1 March 2024

K200826-3

**GEOTECHNICAL RESPONSE TO COUNCIL SECTION 92 REQUEST FOR FURTHER INFORMATION - BUN60406128 (LUC60406129, SUB60406160), WAT60412104 & DIS60412103 PROPOSED SUBDIVISION - 2127 KAIPARA COAST HIGHWAY, MAKARAU**

Safety Factor

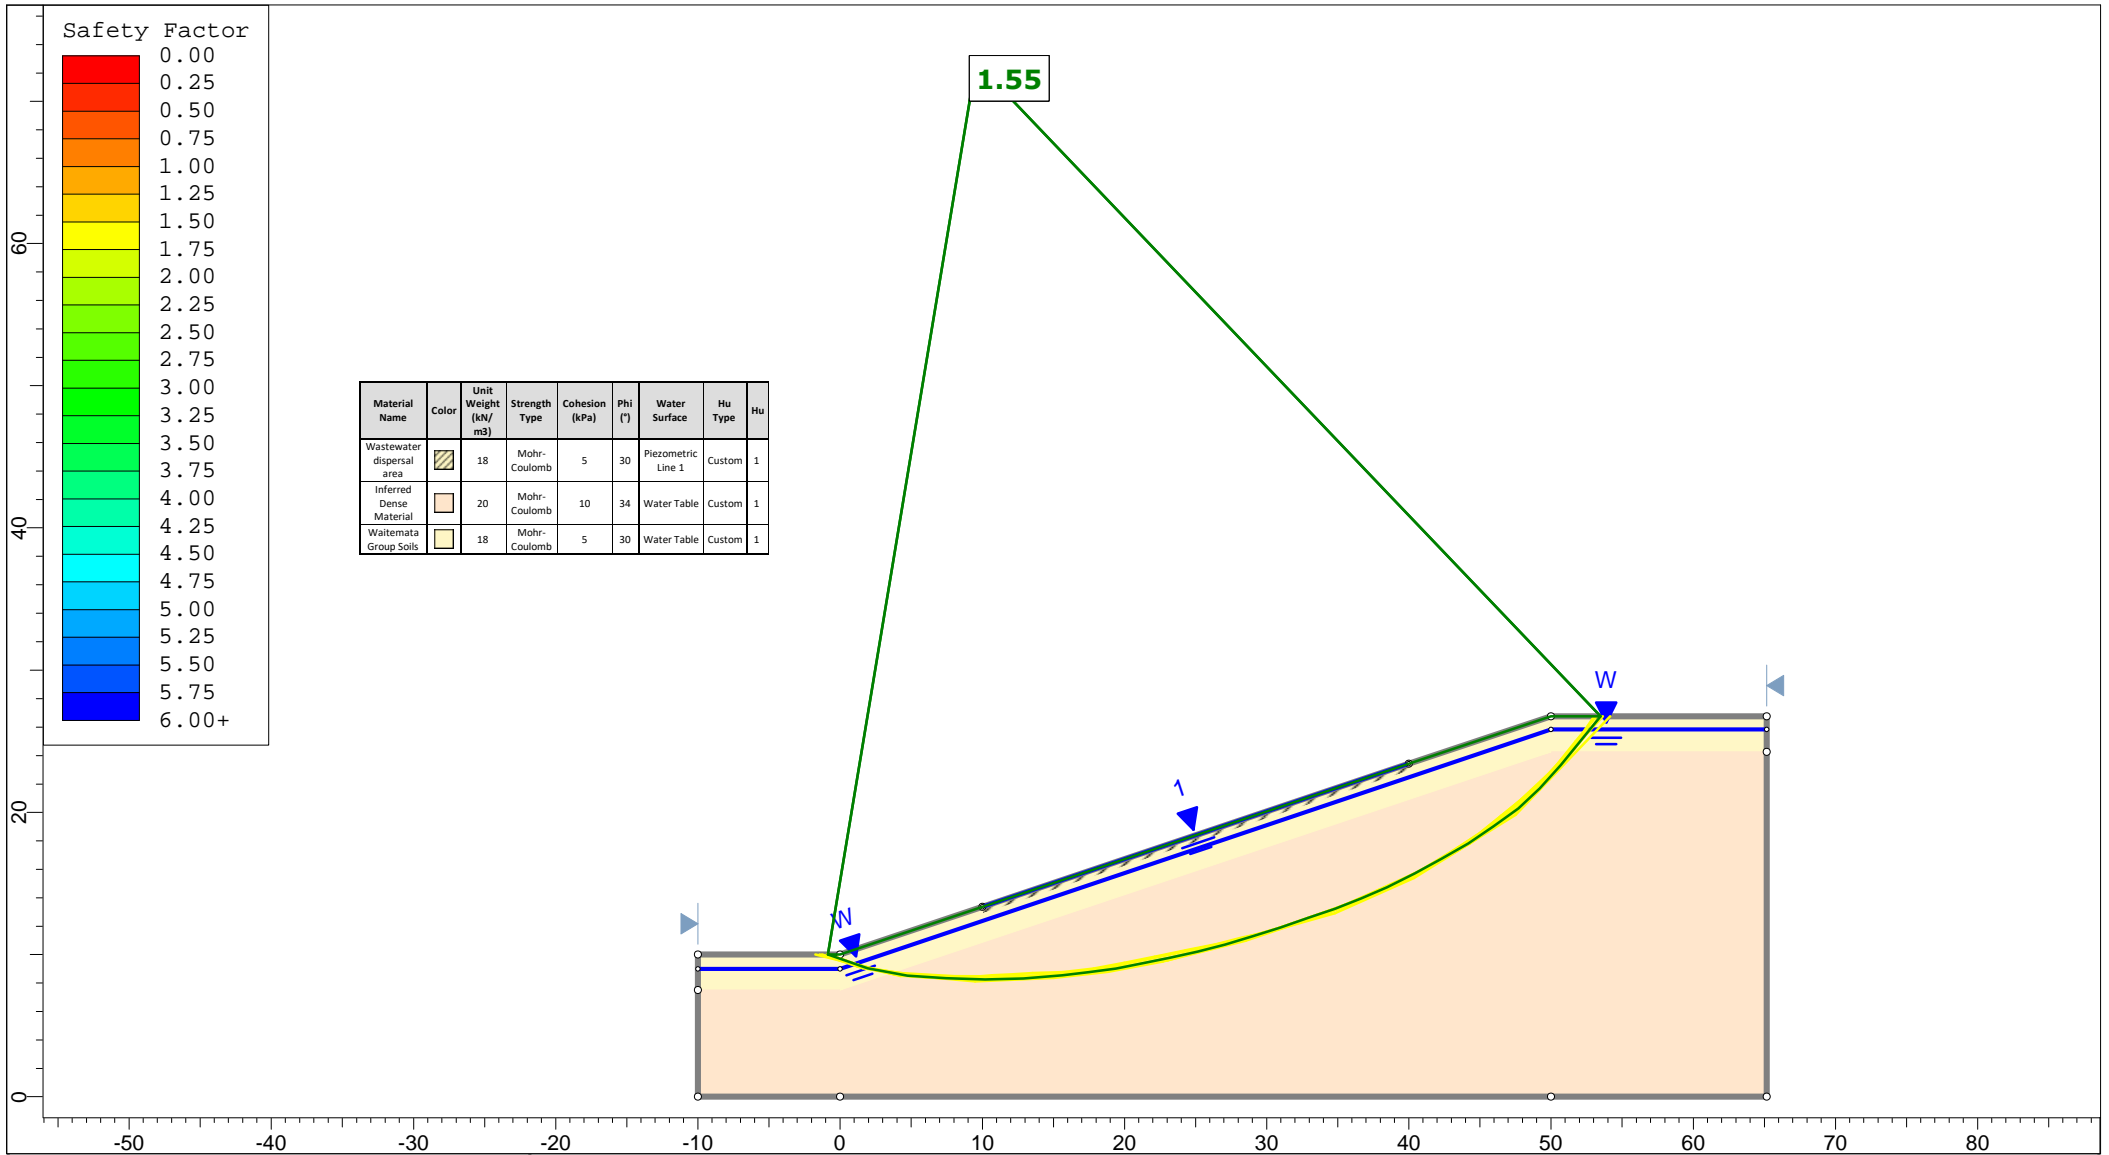
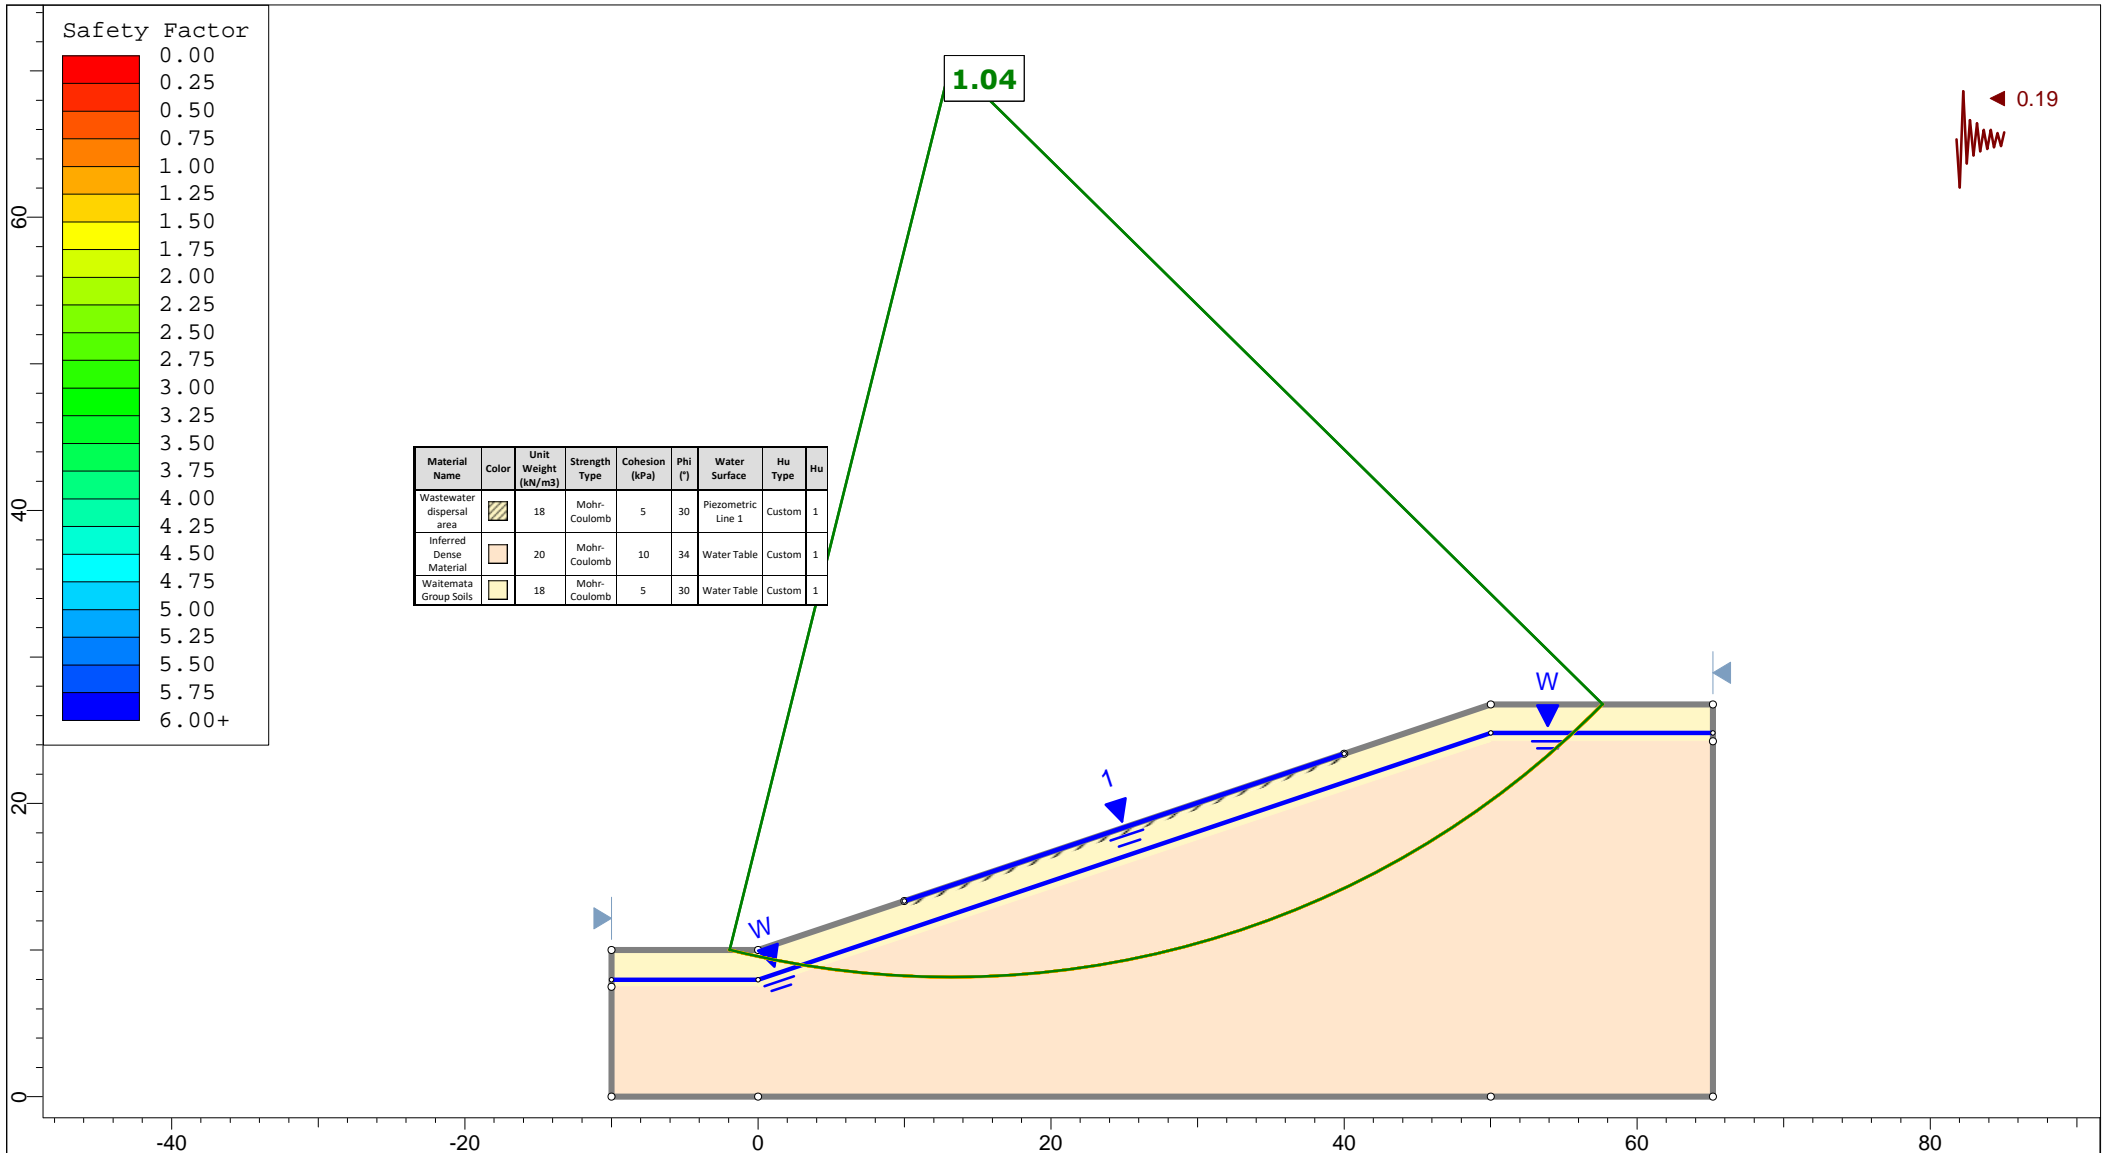
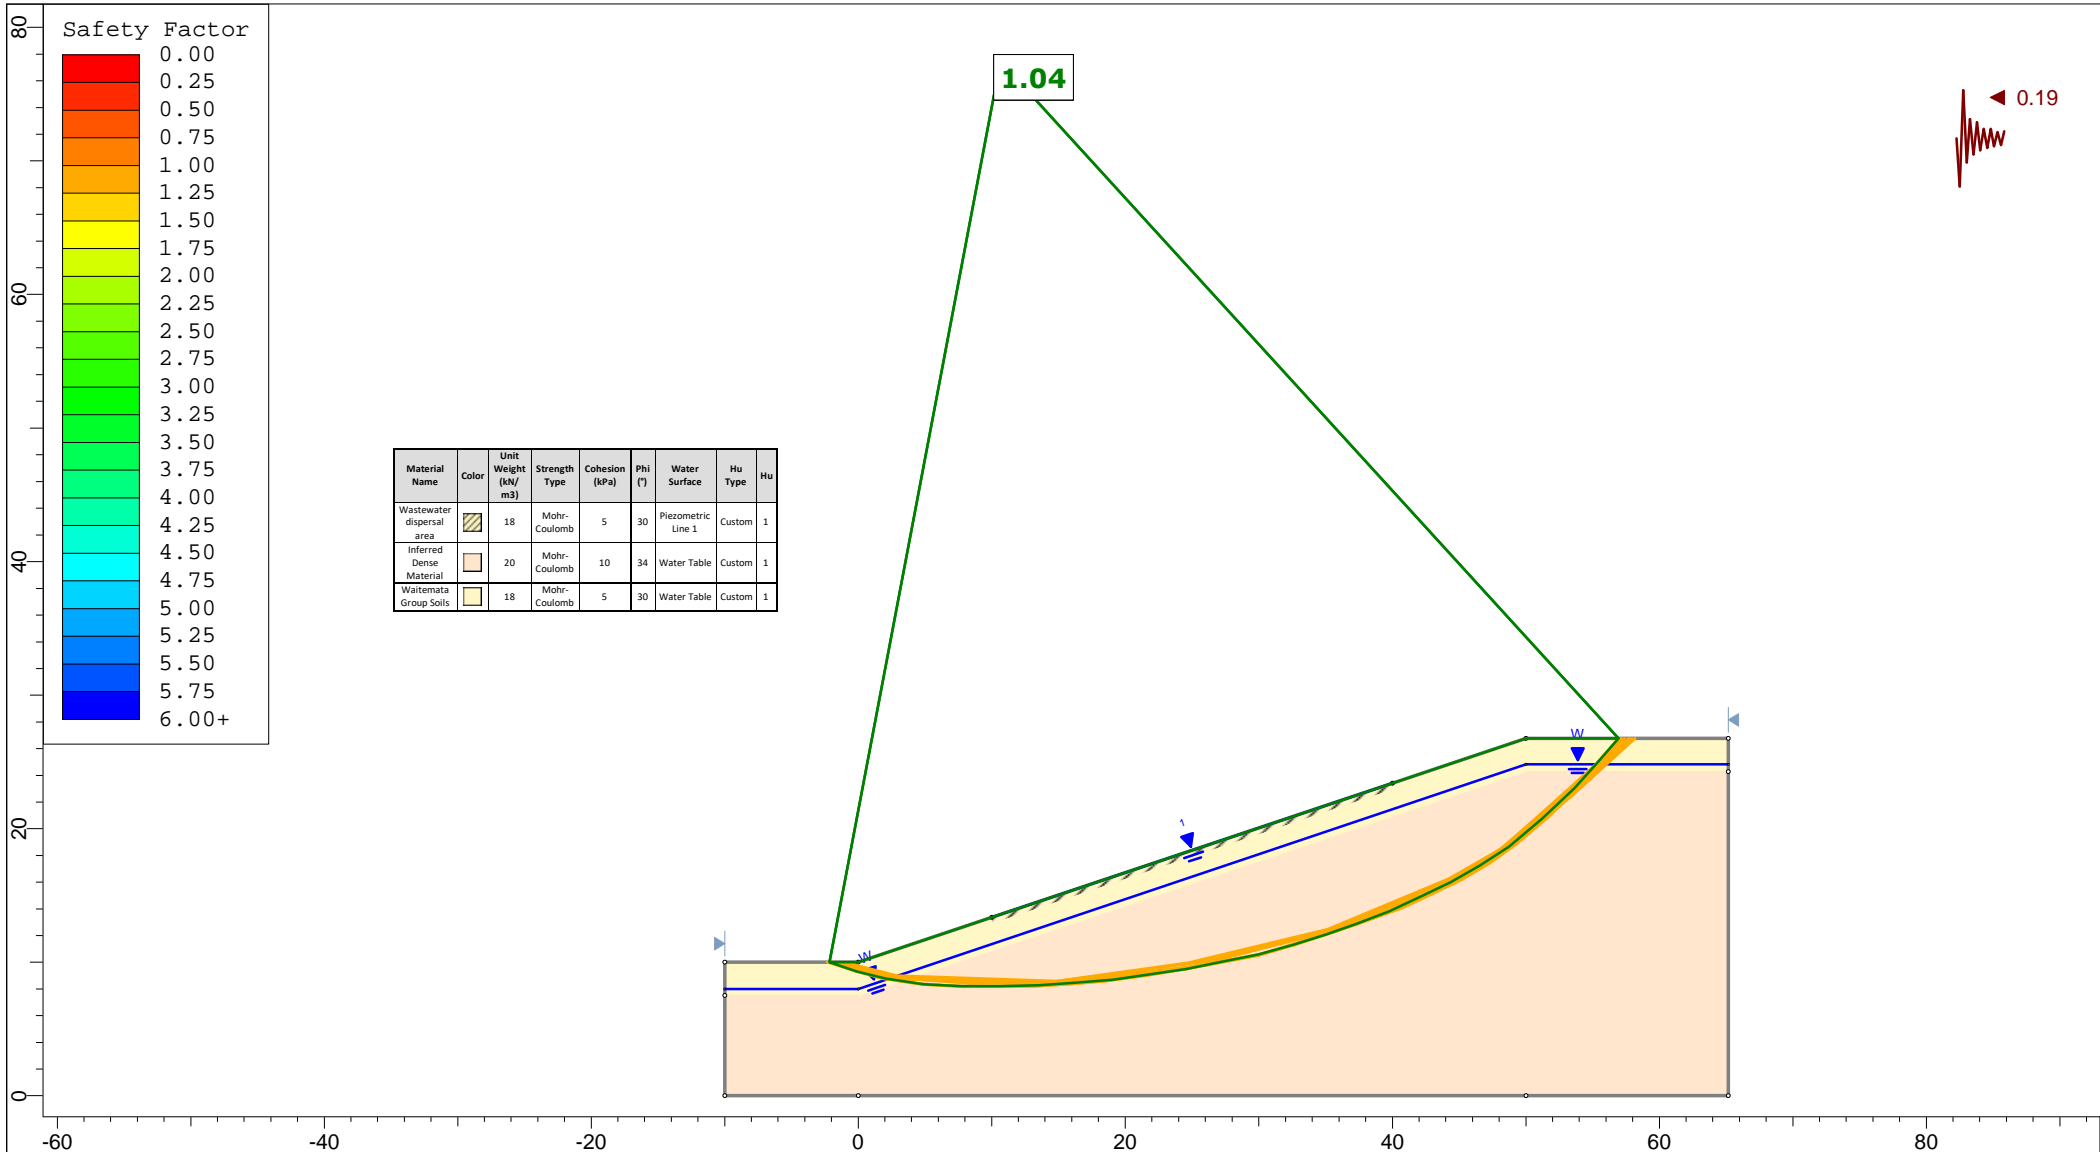
*Please clarify how the proposed wastewater dispersal fields have been considered in the slope stability analysis.*

To satisfy this RFI item a critical case cross-section with a 30m wastewater dispersal area (lateral extent dispersing on 1 vertical on 3 horizontal slope (18 degrees) was prepared and assessed using the computer-based program “SLIDE 2” by RocScience.

In carrying out the analyses, the upper 500mm of material below the wastewater dispersal area was modelled assuming a fully saturated state (perched groundwater table with a soil  $H_u$  value of 1). The ground surface has been modelled utilising three separate case scenarios:

A summary of the Factor of Safety results from the analyses is presented in Table 2 below. For detailed results, the slope stability calculation has been attached to the rear of this letter.

The results of the stability analyses indicate that the sloping ground have acceptable Factor of Safety results for all conditions in accordance with “Auckland Code of Practice for Land Development and Subdivision, Chapter 2: Earthworks and Geotechnical”, July 2022. As such, as a preliminary assessment we considered the proposed wastewater dispersal areas feasible.
